Administrative Change Approval Form Order

East Port Water Reclamation Facility Expansion

Contract #:	2023000485	Change Order #:	5
Original Contract:	$106,188,600.00	Original Contingency:	$5,309,430.00
Previous Change Orders:	$316,884.91	Previous Contingency Changes:	$424,489.64
This Change:	$134,811.70	New Contingency Balance:	$4,750,128.66
Revised Contract Amount:	$106,640,296.61	Original Contract Time:	900 days
Current Completion Date:	12/30/2026	Previous Additional Time:	173 days

CCU Change Order Request
East Port WRF Expansion - Poole and Kent
Change Order #5

LAYOUT OF IR PUMP STATION SLAB & PAD REINFORCING DETAILS

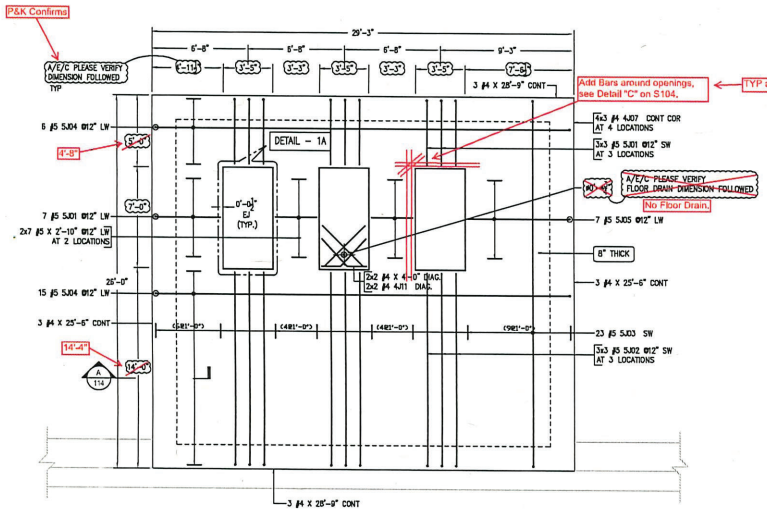
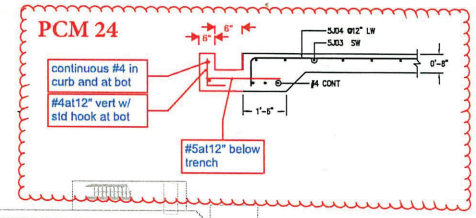
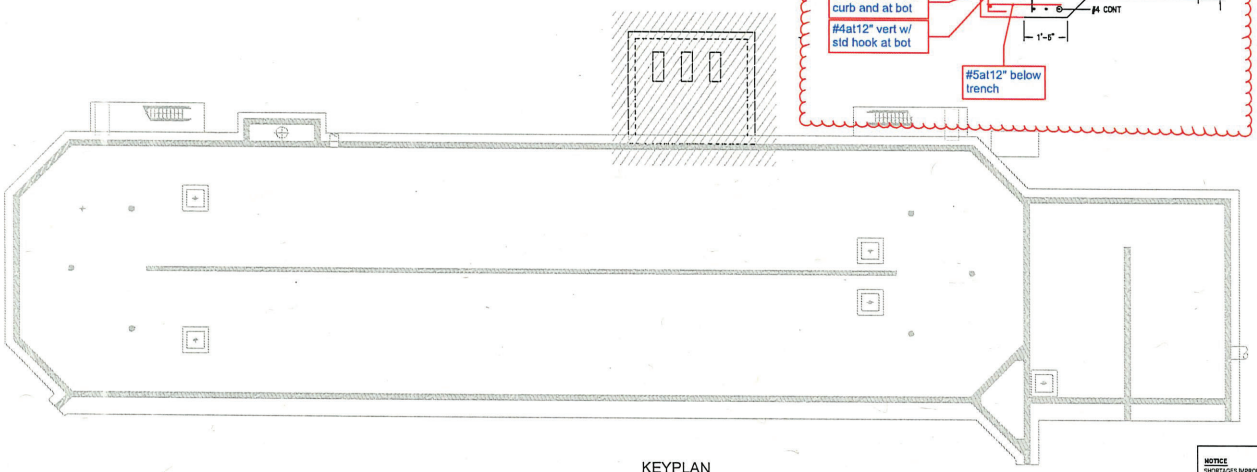
CONTRACTOR PLEASE VERIFY EQUIPMENT PAD DIMENSIONS & REINF. DETAILS FOLLOWED

A/E/C PLEASE VERIFY LAP SCHEDULE FOLLOWED

A/E/C PLEASE VERIFY COVER DETAILS FOLLOWED

REVISE & RESUBMIT

IR PUMP PLAN AND SECTIONS

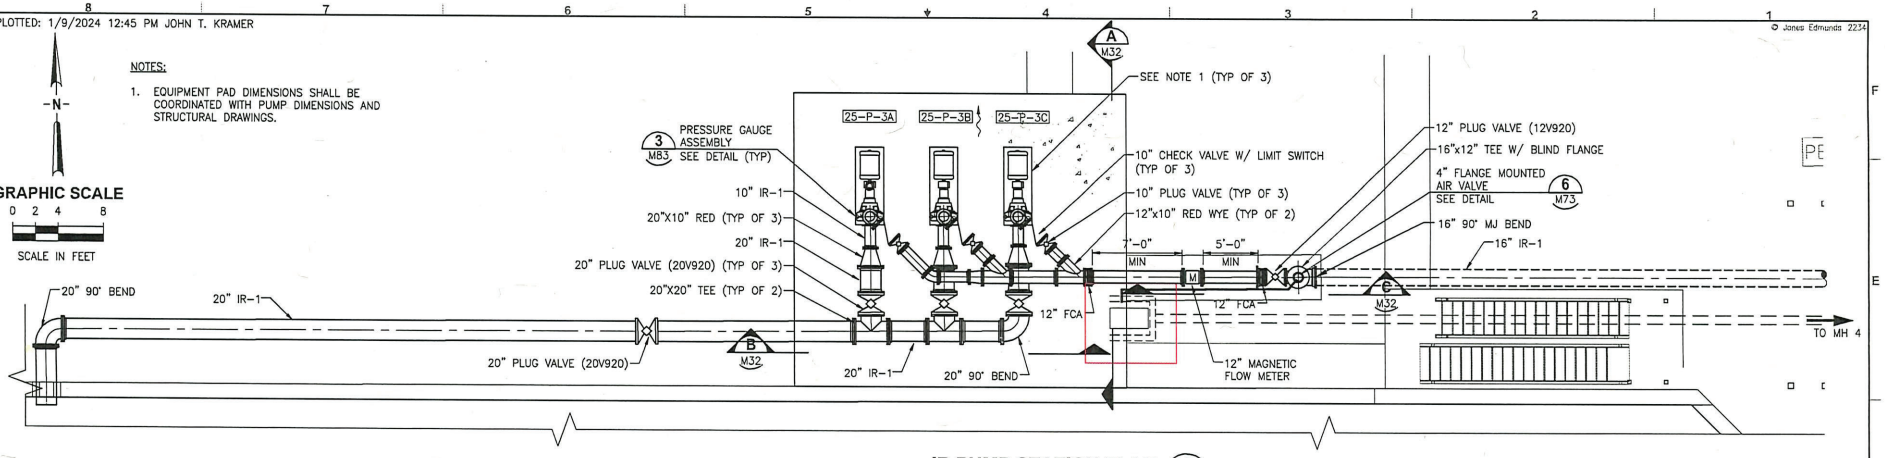
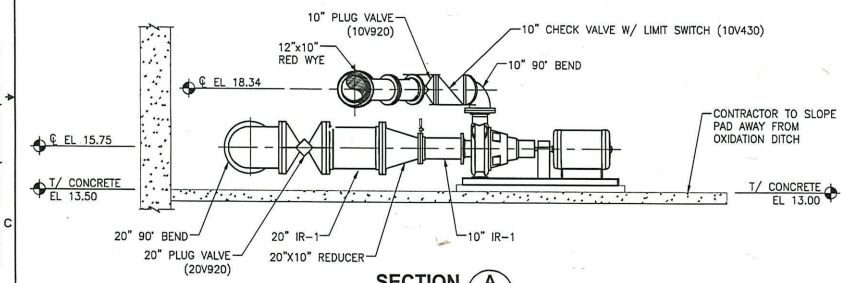
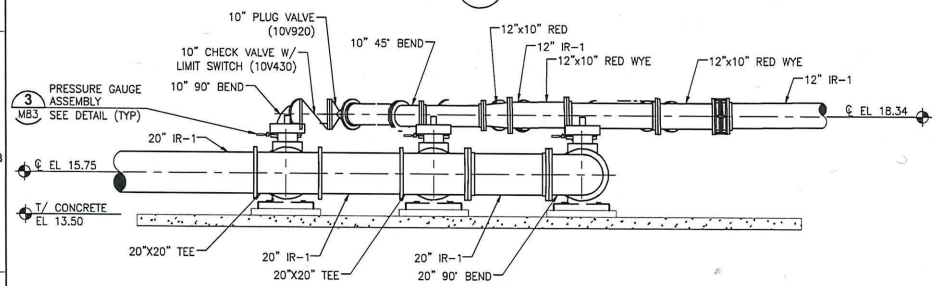
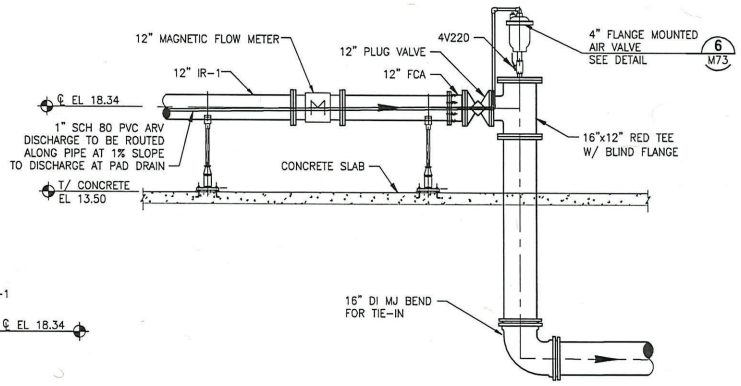
Please see the attached RFI regarding the IR Pump Pad drain. This is shown only on the mechanical drawings with no detail on what is intended to be installed or used as the drain, please review and advise.

Please clarify the design intent on the IR Pump Pad Drain. This Drain is only shown on the overview Mechanical drawings. There is not details or structural drawings for this. Please provide further details and layout on what is intended to be installed or made for the IR Pump Pad Drain.

is Described Below or in the Attached: Please install per attached markup - PDF pages 2 & 3.
PCM to follow.

DESCRIPTION OF MODIFICATION: Please submit your proposal for an equitable adjustment in the contract amount and/or performance time in accordance with the following:
Revised Drainage Configuration

REASON FOR MODIFICATION: To accommodate wash down procedures.
